2. 11 Mall Road - Game On & Loretta's Last Call

PLANNING BOARD AGENDA FOR JANUARY 13, 2026 - 7:00 PM

Below please find our responses comments discussed in our December 9, 2025 meeting and at the PB meeting. Below please find each comment followed by our response in **bold.**

LYONS GROUP RESTAURANT
AT THE MALL AT ROCKINGHAM PARK
PLANNING BOARD SUBMISSION

Project No.	Drawing No.
151041901	VT901
Date: OCTOBER 23, 2025	
Drawn By: BAL	
Checked By: ICW	Sheet 1 of 1

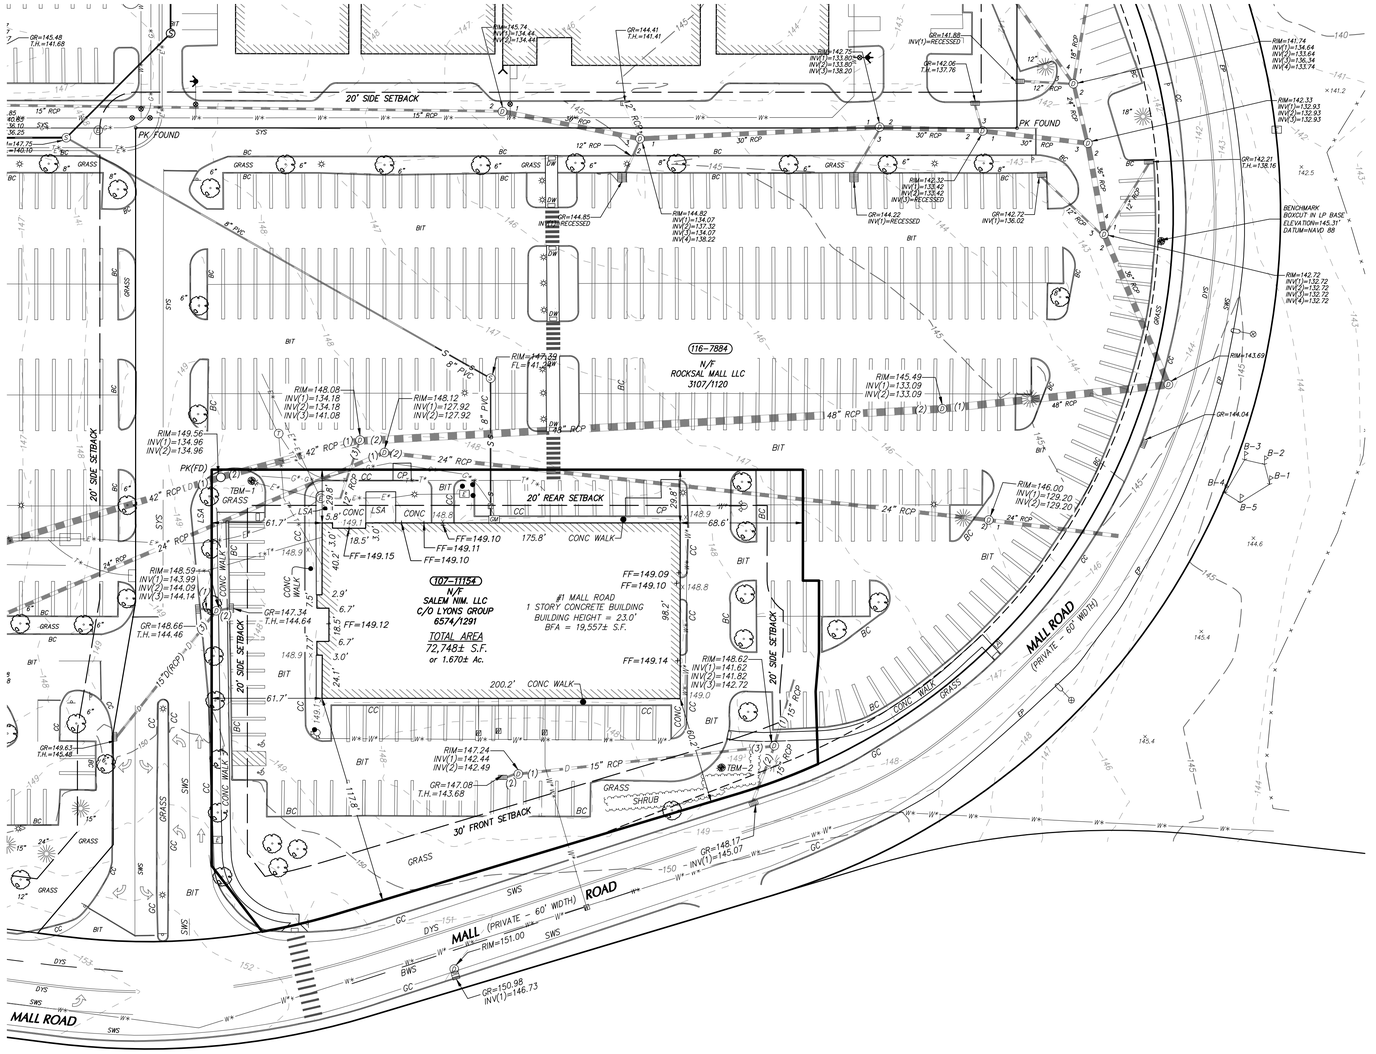
- Eliminate zoning table on Existing Conditions Plan

COMMENT RESPONSE: Zoning Table has been removed from VT901.

12/29/25	RESPONSE TO COMMENTS	1
CS101	EXTERIOR SITE PLAN

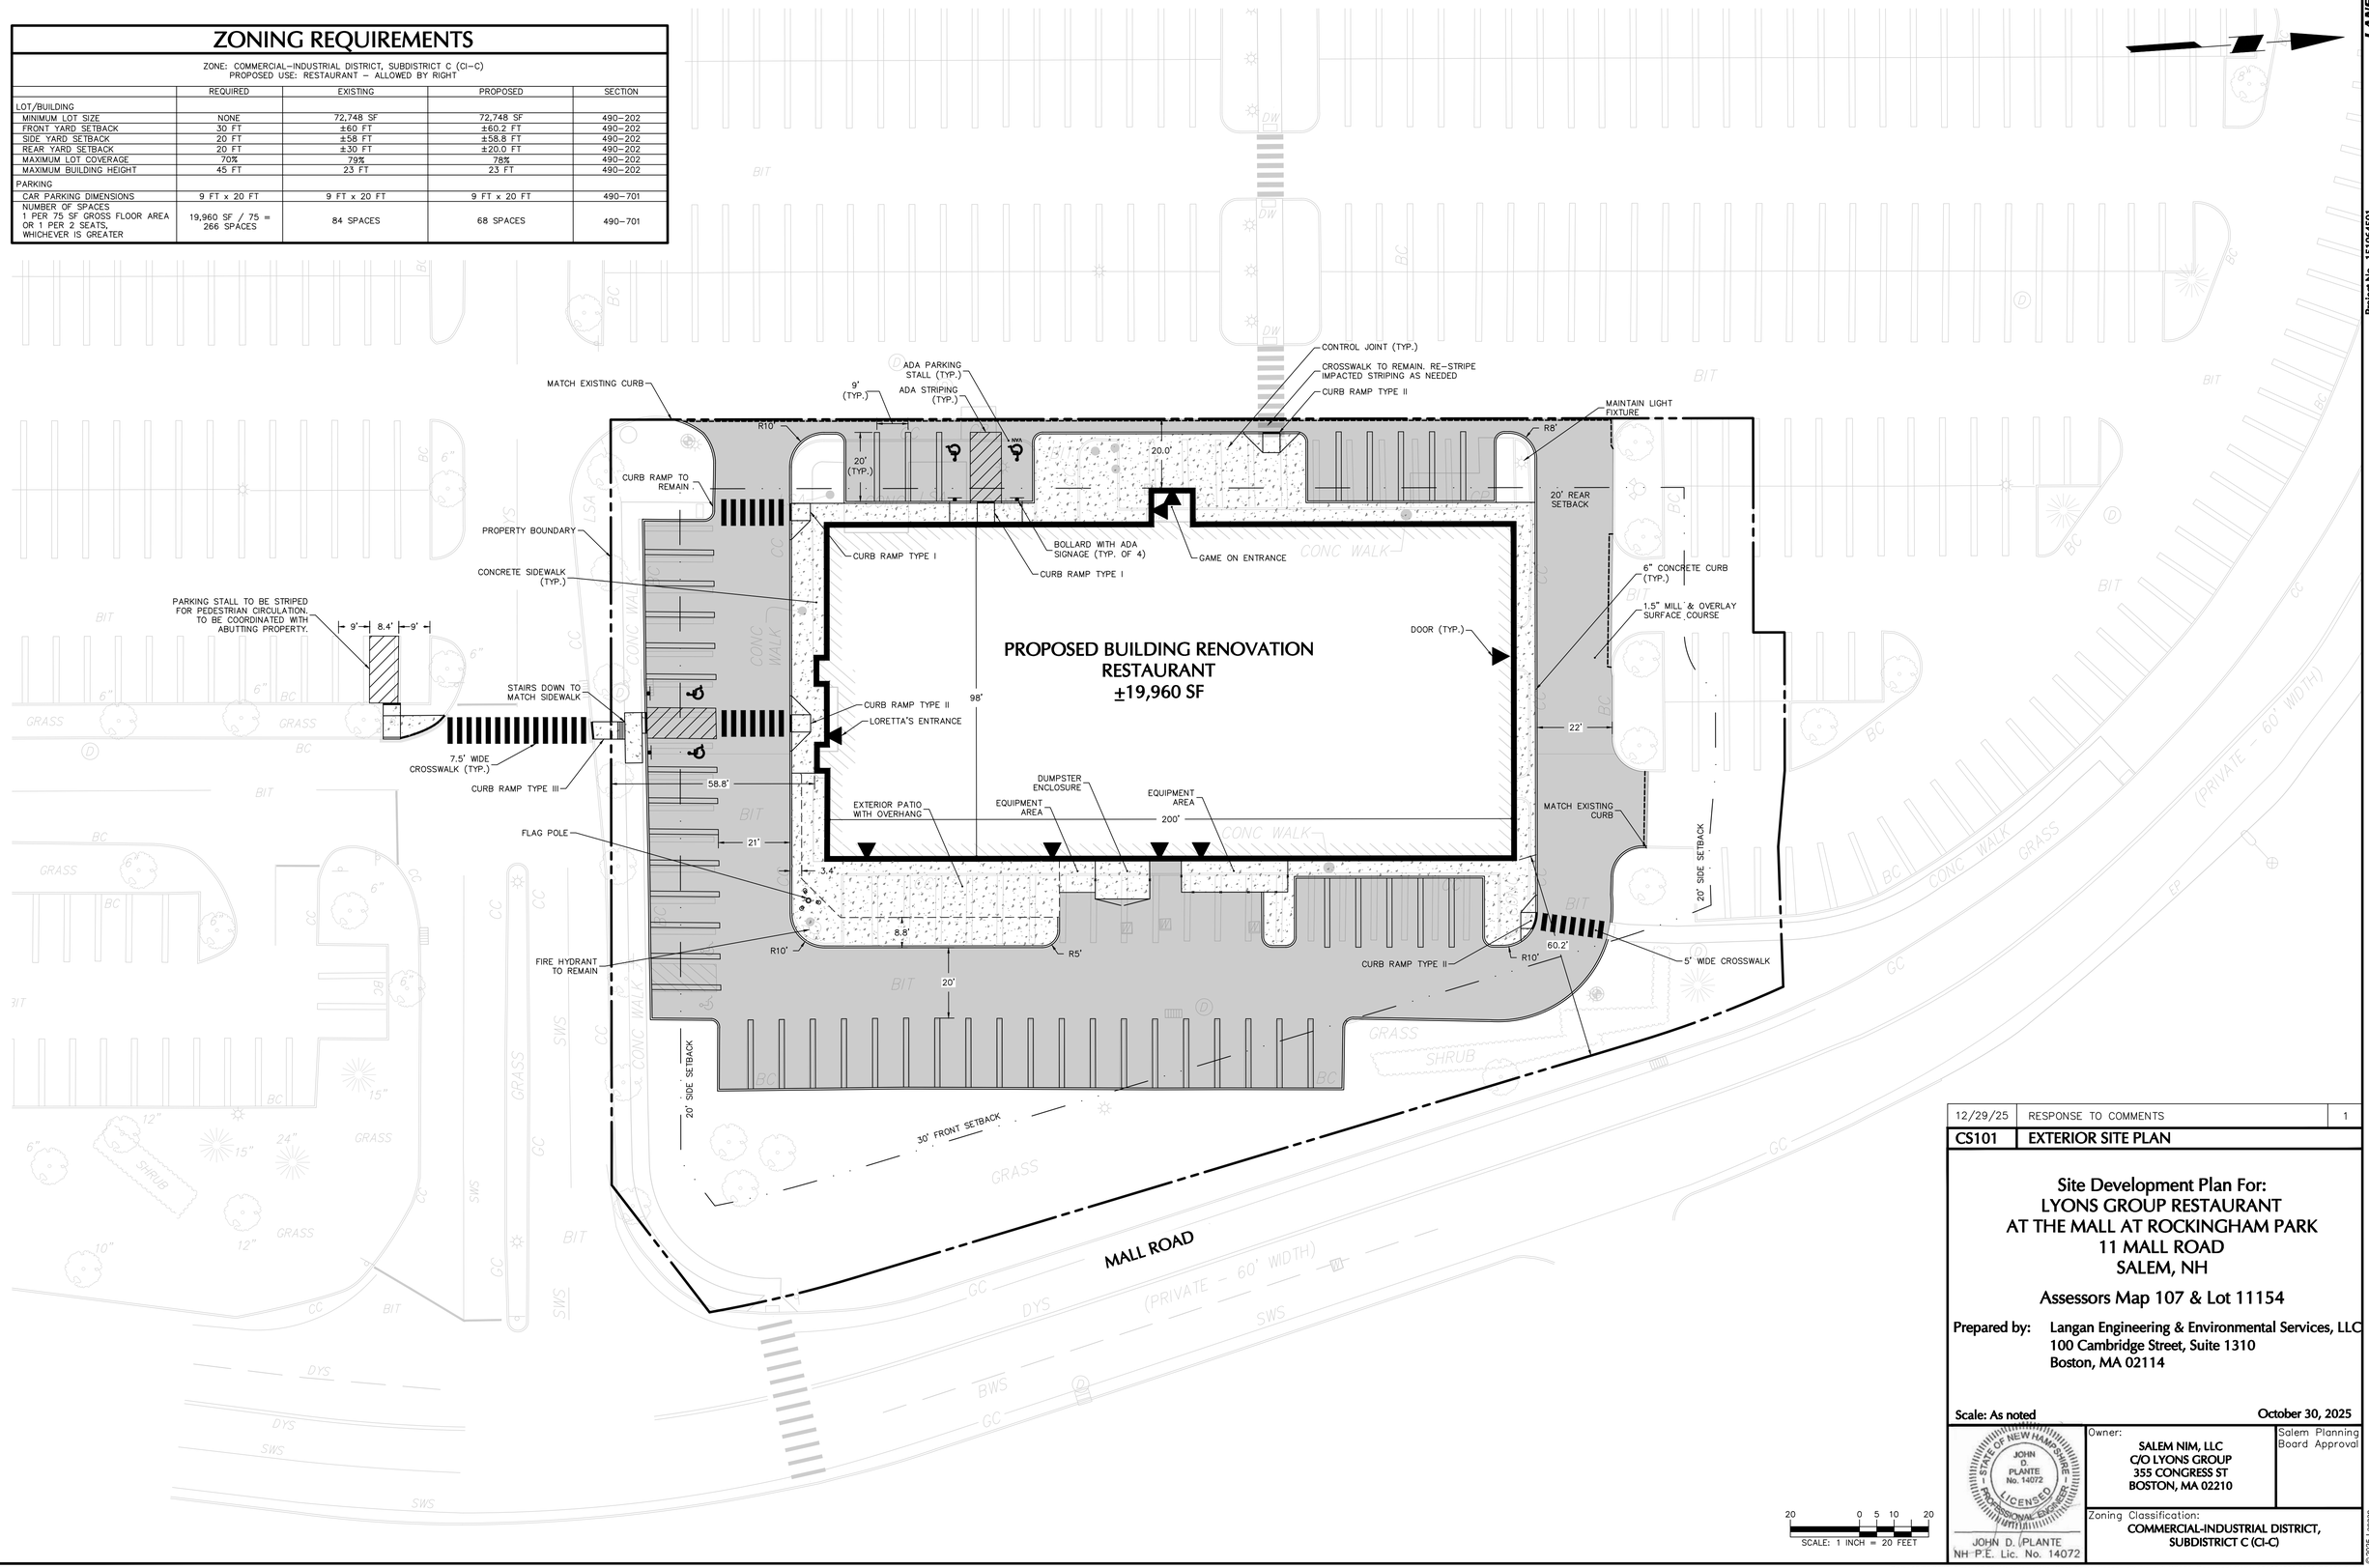
- Site Plan:
  - Add pedestrian connection to north sidewalk

- Add tip down at ADA spaces to ped. connection to south

- Add dimension of striped space to south

COMMENT RESPONSE: Curb ramp with crosswalk has been added to the plans. Please see CS101.

COMMENT RESPONSE: Tip down to ADA spaces has been added to south sidewalk connection, as seen on CS101.

COMMENT RESPONSE: Dimensions have been added to restriped southern parking area, seen on CS101.

COLORED EXTERIOR ELEVATIONS

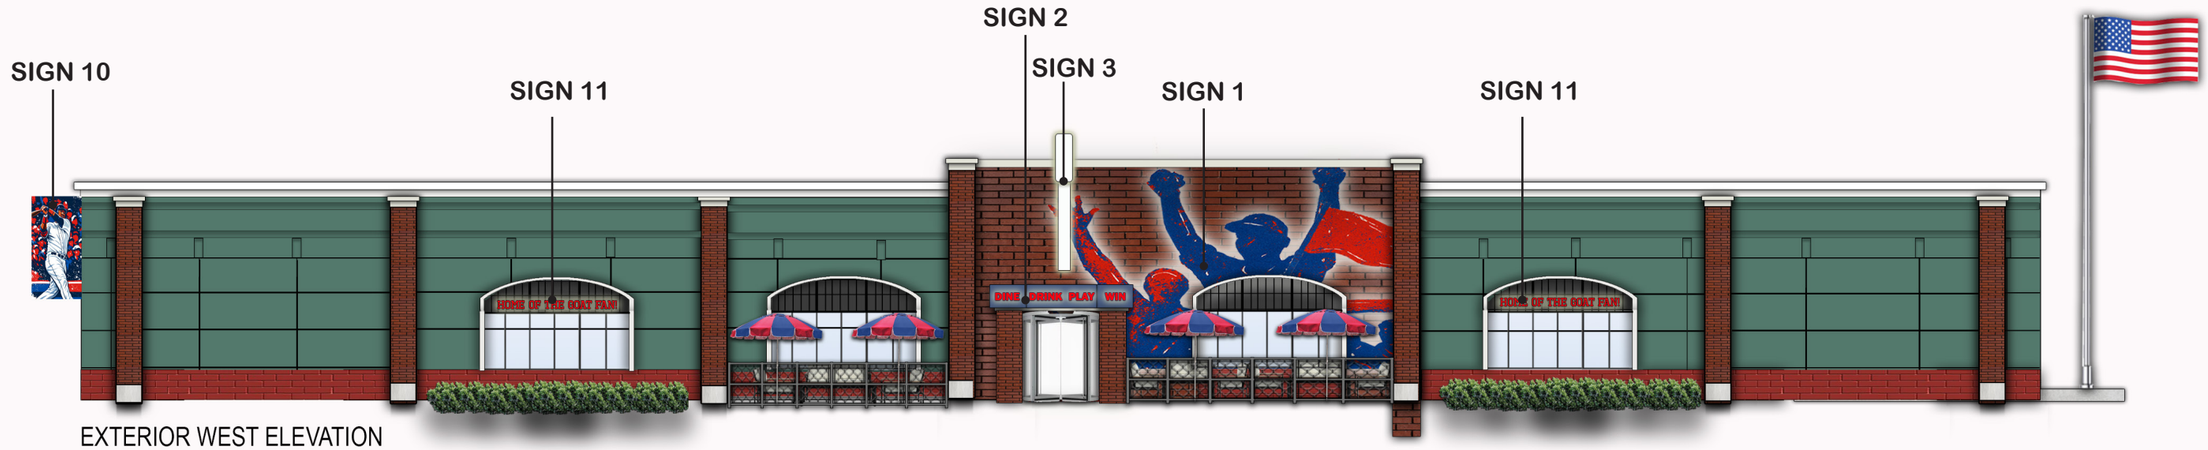
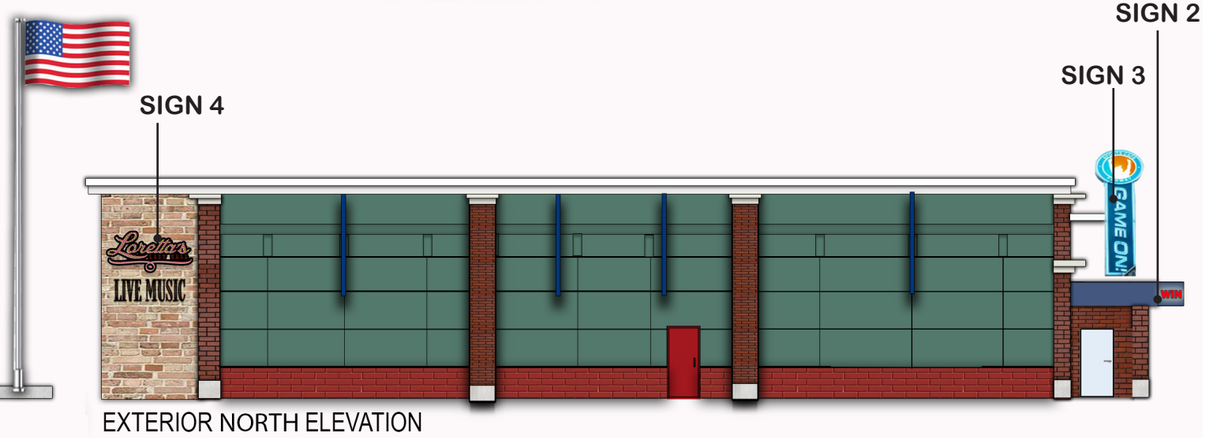
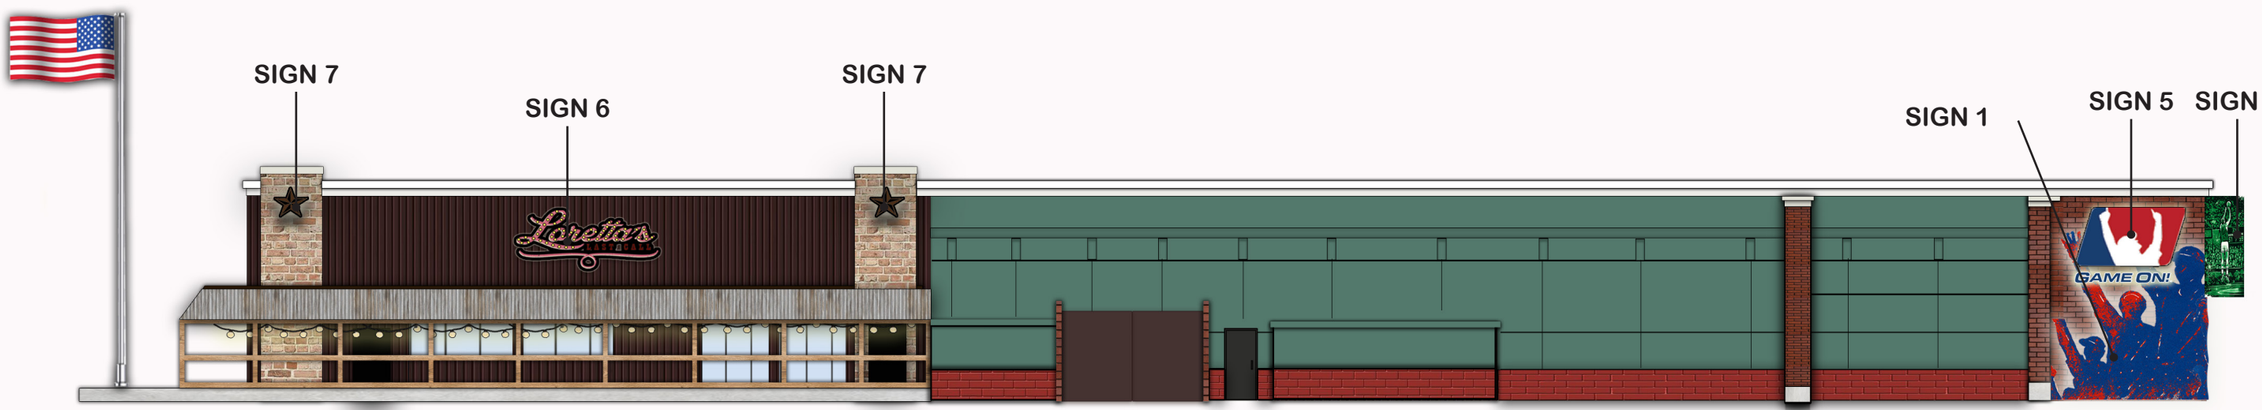
- Elevations:
  - Add legend – materials and color

COMMENT RESPONSE: **Additional page has been added to the plans with the legend.**
